COUNCIL ACTION FORM

REQUEST: **PRELIMINARY PLAT FOR A 121-ACRE, 150-LOT RESIDENTIAL SUBDIVISION KNOWN AS SCENIC VALLEY SUBDIVISION**

Attachment B: Lot Layout (Close-up)

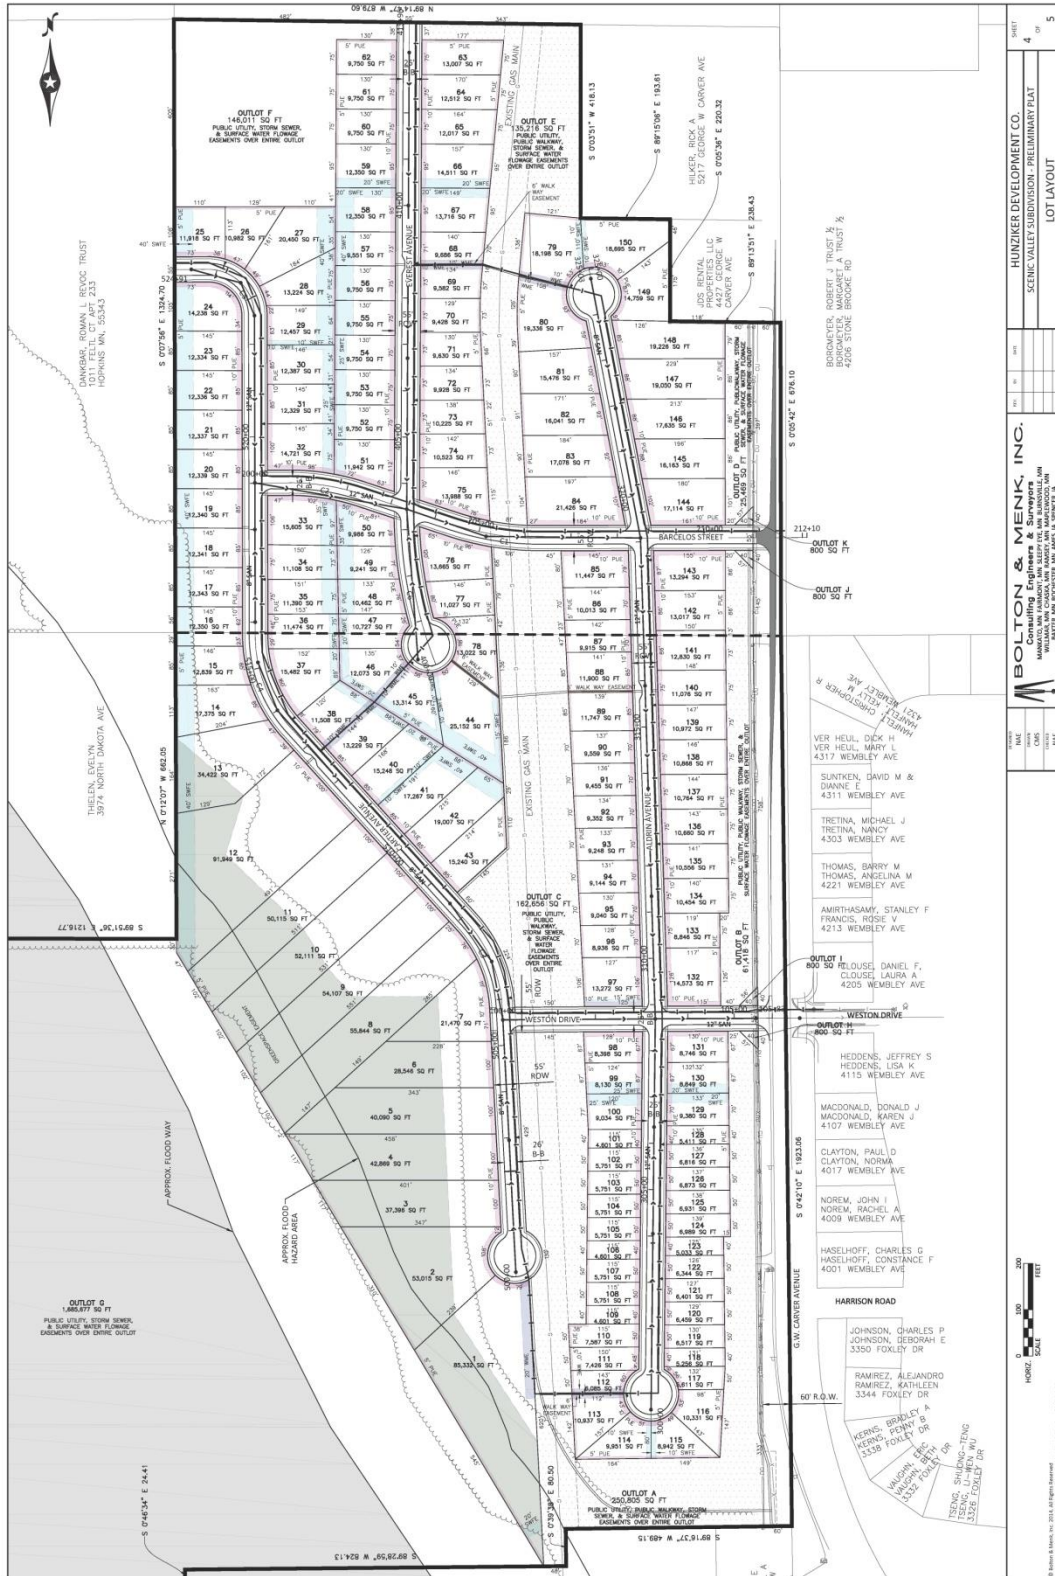
A street tree planting plan has been submitted that meets the standards of the subdivision standard. **However, because of the density of attached homes on the south portion of Aldrin Avenue, it is anticipated that there will be conflicts between street trees, street lights, driveways, and on-street parking. Staff recommends as a condition of approval of this preliminary plat that, prior to final**

plat approval, the street light and street planting plan for that portion of Aldrin Avenue will need coordination with the Planning and Housing Department to ensure that there is space for placement of street trees and to allow for on street parking.

1. The City Council can approve the preliminary plat for Scenic Valley Subdivision at 3699 George Washington Carver Avenue with two conditions:
 - A. Prior to final plat approval, the street light and street planting plan for the attached single-family home portion of Aldrin Avenue south of Weston Drive will be prepared and presented to the Planning and Housing Department for review and approval to ensure appropriate space is reserved for off-street parking coordinated with driveway placement.

Attachment C: Master Plan

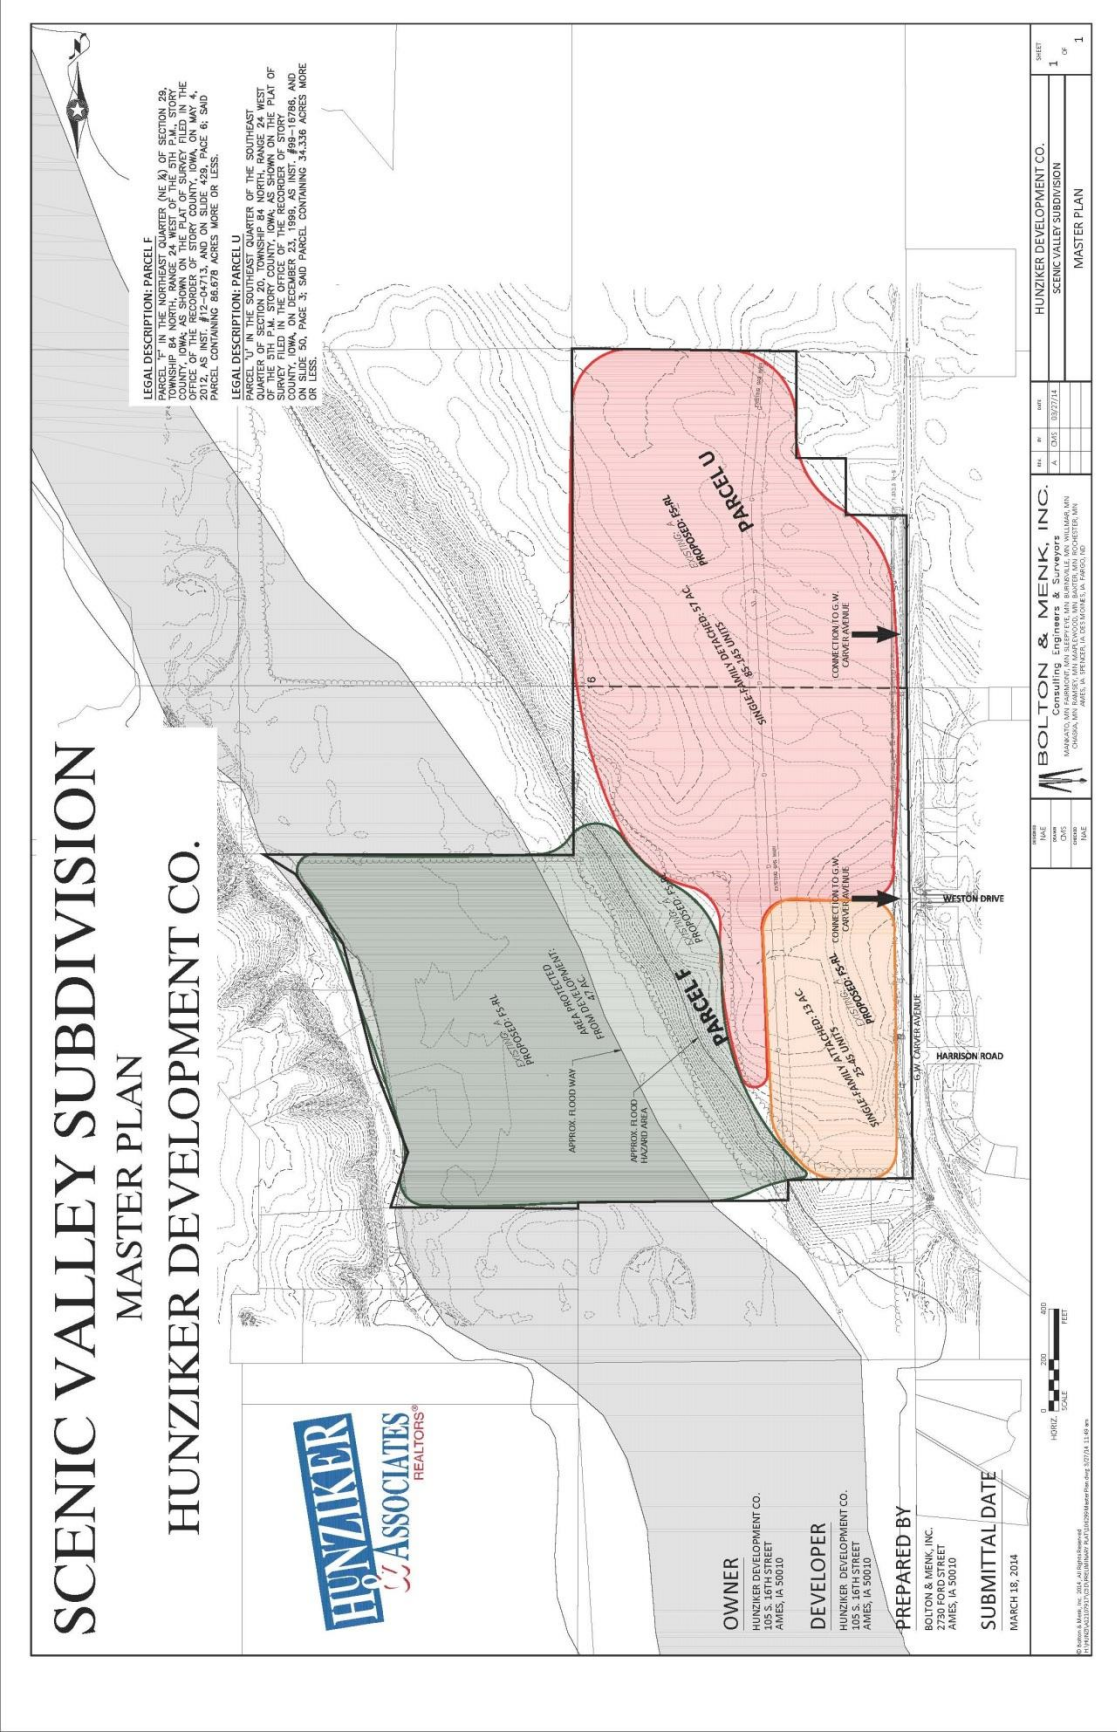
Natural Area and Steep Slopes. A portion of this land lies within the Environmentally Sensitive Overlay Area of the Land Use Policy Plan. This includes land within the flood hazard zone of Squaw Creek, the steep slopes that rise approximately 40 feet from those bottomlands, and a thinly wooded area on the slopes and the edge of the uplands. The Master Plan contains language stating the intent of the developer to allow some limited activity within the area and describing prohibited activities. These are expressed in general terms and are quoted below.

“The general boundary shown in orange shall be the limits of any habitable structures. Overgrowth and scrub trees may be removed within this area to allow for structures. Dead trees may be removed from this area. Emphasis should be placed on preserving existing healthy trees. Ash trees may be removed at any time.

“The general boundary shown in green shall be prohibited from building habitable structures. Dead, dangerous, and diseased trees may be removed from this area. Other trees may selectively be removed to improve the overall quality and health of the existing trees. Emphasis should be placed on preserving as many healthy trees as possible in this area. Ash trees may be removed at any time. Gazebos, non-habitable structures, and walking paths are permitted in this area. Gazebos, structures, excavation, and removal of cover on the steep slopes should be avoided whenever possible.”

Staff recommends as a condition of approval that an easement containing specific language regarding the protection of trees and slopes within the orange and green areas as shown on the master plan will be needed with final plat approval.
